Subject: Minutes of the February 15, 2008 MAGNASTOR Draft RAI Teleconference  
Docket No. 72-1031 (TAC No. L23764)

Attachment 1 – MAGNASTOR Draft RAIs, NRC Conference Call February 15, 2008

**MAGNASTOR Draft RAIs**  
**NRC Conference Call February 15, 2008**

**Figure 3.8.3-1 Overall Model Plot for a Typical PWR Fuel Assembly**

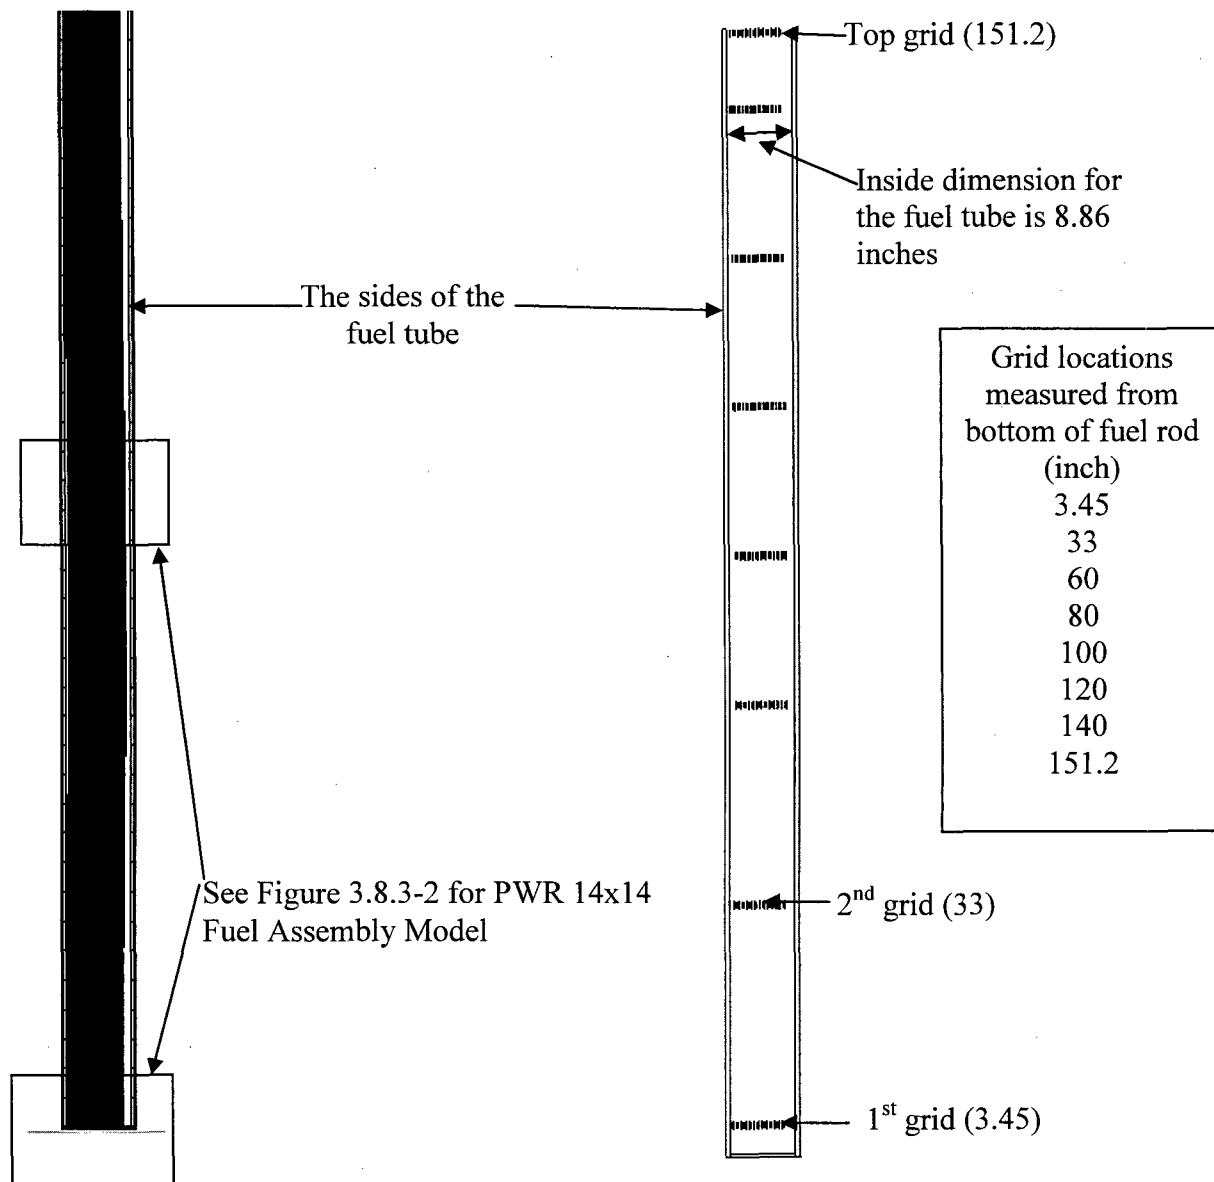
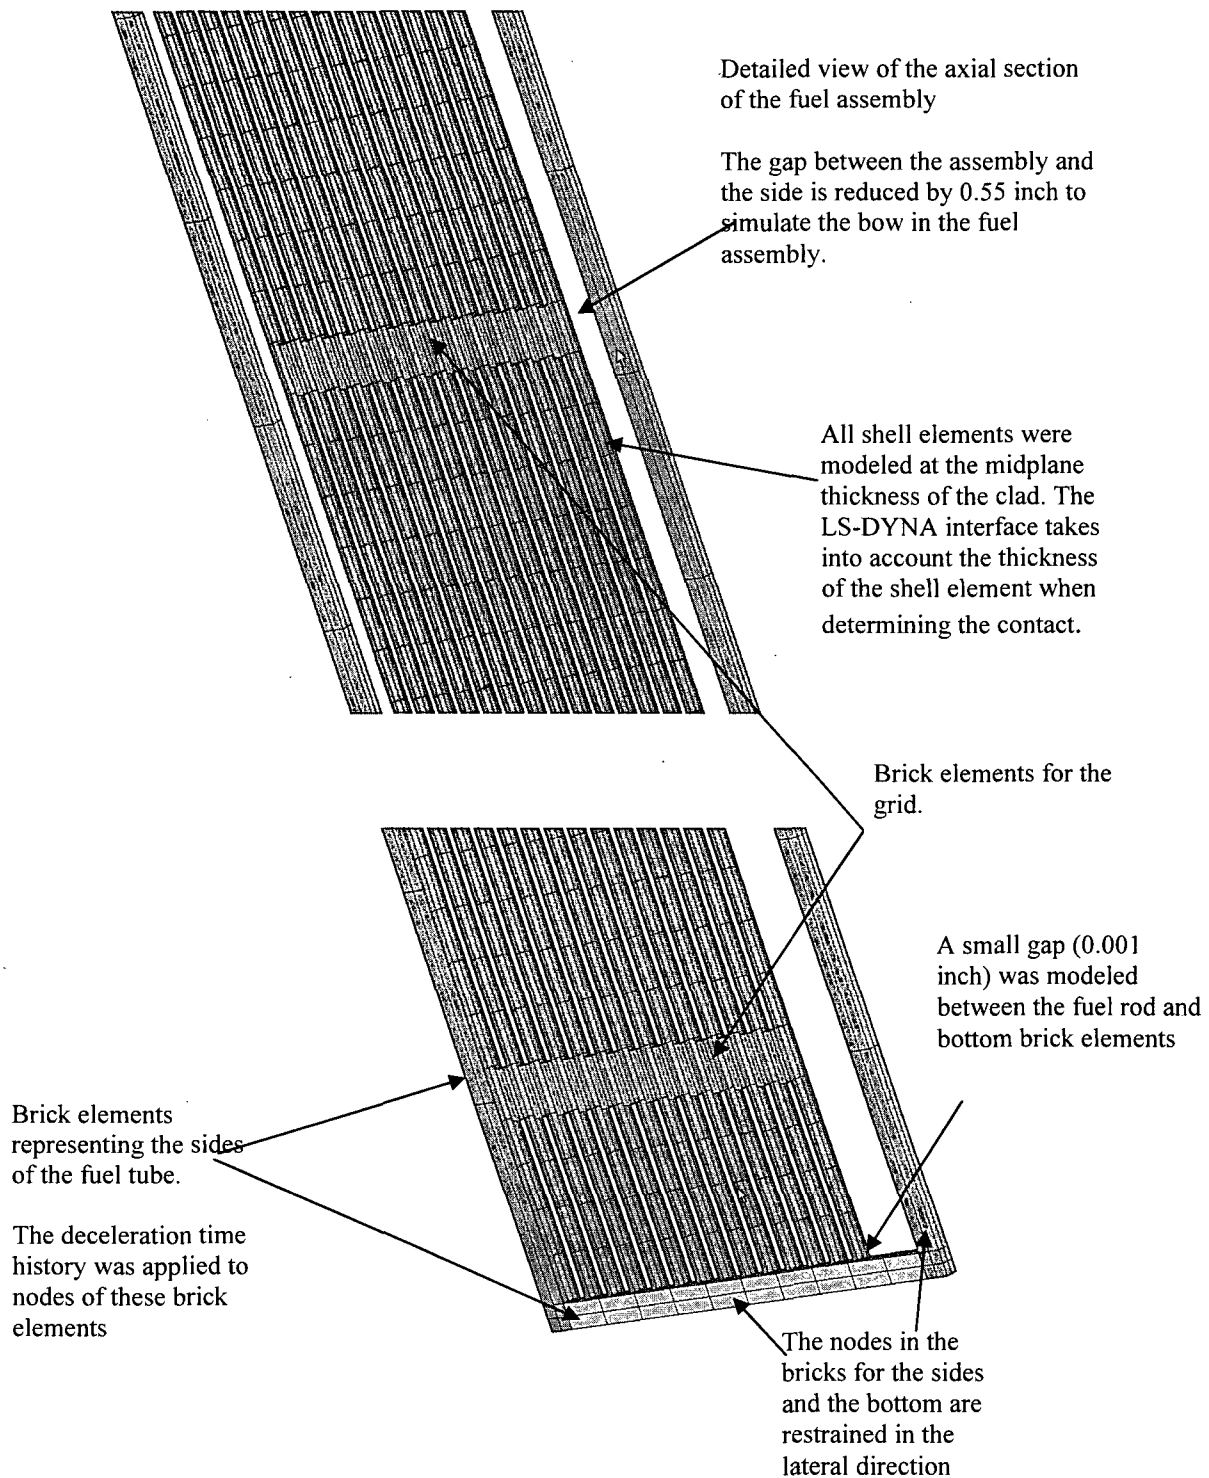
Revise Section 3.8 of the SAR fuel rod structural analysis for the 24-inch handling height concrete cask vertical drop accident. Add a fuel rod structural integrity evaluation for the side-drop impact associated with the concrete cask tip-over accident.

Section 3.8.1 will be replaced by the following presentation:

### 3.8.1 PWR Fuel Rod Buckling Evaluation

This section presents the buckling evaluation for MAGNASTOR high burnup PWR fuel (burnup greater than 45,000 MWd/MTU) having cladding oxide layers that are 80 and 120 microns thick. A reduced cladding thickness is assumed due to the cladding oxide layer. These analyses show that the maximum stresses in the high burnup PWR fuel remain below the yield strength in the design basis accident events and confirm that the fuel rods will return to their original configuration. A 24-inch end drop orientation of the concrete cask subjects the fuel rods to axial loading. The 24-inch drop evaluation employs two acceleration time histories. The 24-inch concrete cask end drop described in Section 3.10.4.3 resulted in the acceleration time history shown in Figure 3.7.3-2. The maximum acceleration for the time history shown in Figure 3.7.3-2 is 25.3g's (the strong segment of the pulse lasts for 0.015 second). A bounding triangular shaped time history with a maximum acceleration of 45g's for a duration of 0.02 second is also used.

## RIG SET MODULAR AIR BEARING SYSTEMS

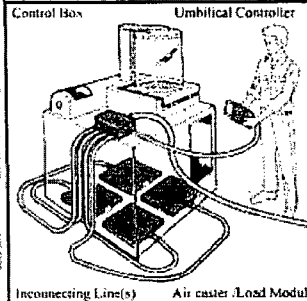
Clarify the description of Air Pad Rig Set provided on Table 9.1-1 of the SAR. Currently the SAR states the following description: "A device...air supplied at a high volume". The description should be modified as follows: "A device...air supplied at a high pressure." This information is needed to assure compliance with 10 CFR 72.11 and 72.236(f).

NAC agreed to provide supplemental air bearing equipment information. Technical data chart information defines system air pressure as 64 psi and air consumption at 435 scfm. Information on the air bearing equipment is provided on the following figure as copied from the referenced website.

**Figure 1-A-1 BWR Partial Length Fuel Rod Location Sketches**

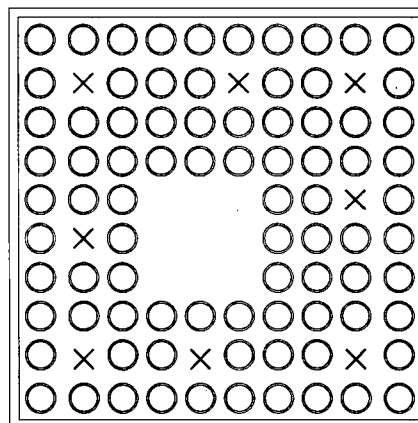
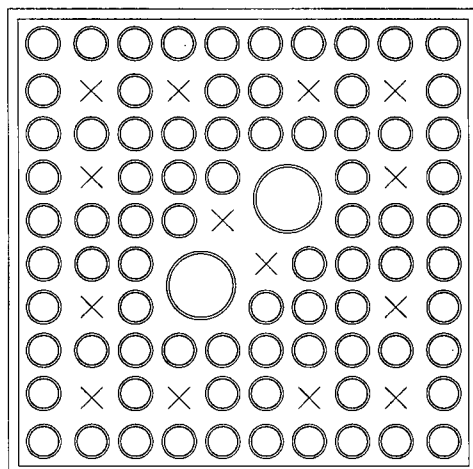
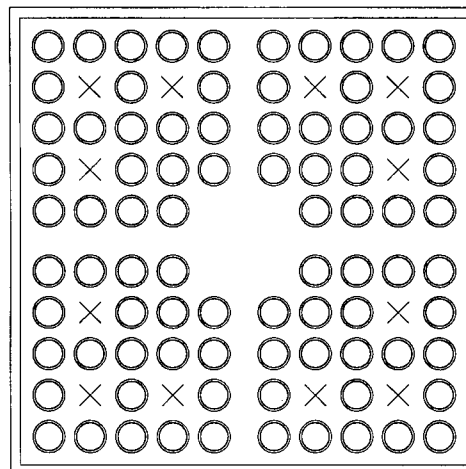
Change footnote a of Table 2-10 in Appendix B of the proposed Technical Specifications to read: Location of the partial length rods is illustrated in Figure 6.2.1-1 of the FSAR (Rev. 1, July 2007).

The current footnote reference does not match the actual figure depicting the locations of the partial-length rods for the applicable assemblies. Furthermore, the reference needs to indicate the appropriate revision of the drawing upon which the criticality analysis and the allowable contents specifications are based. This is necessary because any changes to the applicable assemblies with respect to the positioning of the partial-length rods constitute a change in the allowable contents specifications. This information is needed to confirm compliance with 72.236(a).

“Location of the partial length rods is illustrated in ***Figure 1-A-1*** of the FSAR.”

Appendix 1-A is modified as follows:
